Reply to the comments of Reviewer #2 on the manuscript “Greenhouse gas measurements from a UK network of tall towers: technical description and first results”

Figure 1: 2-hour air history maps derived from NAME for MHD on 29th November 2014. The air-history maps describe which surface areas (0-40m) in the previous 30-days impact the observation point within a particular 2-hour period.

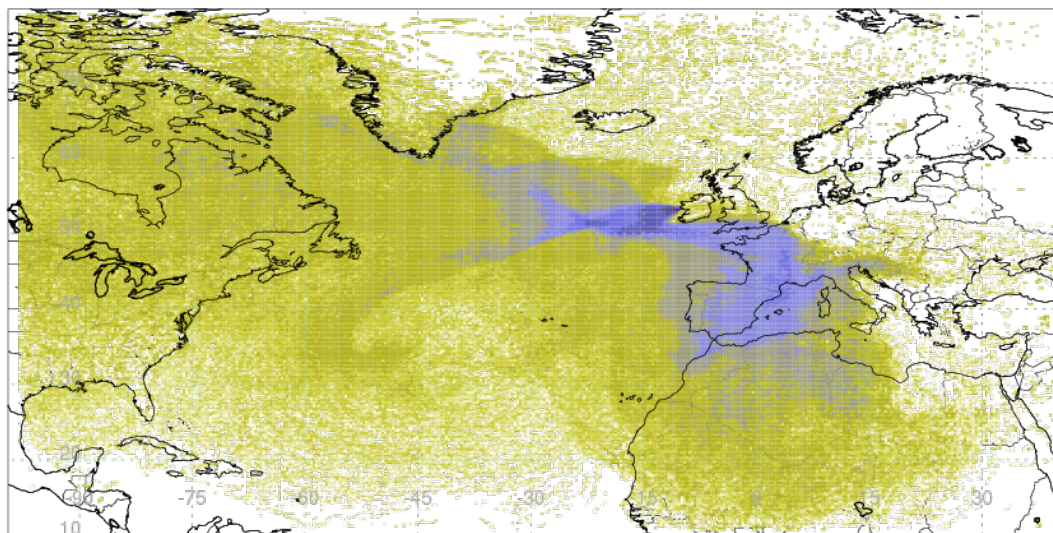
Page 25, line 5: “Fig. 8(b) demonstrates a regionally polluted period at RGL for CH₄ on 30/11/2014, where air has passed over Europe and the south of the UK before arriving at the site“: in such a case we could expect higher CH₄ concentrations at MHD compared to TAC, due to the additional contribution from south UK. Do you such ‘reverse’ gradients sometimes ?

Response: If both sites are receiving the same air masses, then an increasing gradient of CH₄ mole fractions would be expected between RGL and MHD. However, in the instance shown in Figure 8(b), now figure 10(b), the air mass that RGL received was from over the midlands and south of the UK and the Benelux region and Germany; however, at this time, MHD was received air that had passed over the south west of the UK, the west of France and Spain as shown in Figure 1 below. The reverse gradient from that shown in Figure 10(b) – an increasing concentration from west to east over the UK, is frequently observed due to the UK predominant wind direction. Figure 10(a) demonstrates the increasing CH₄ mole fraction with longitude on the 4th and 5th December. A sentence has been added to section 6.3 to reflect this.
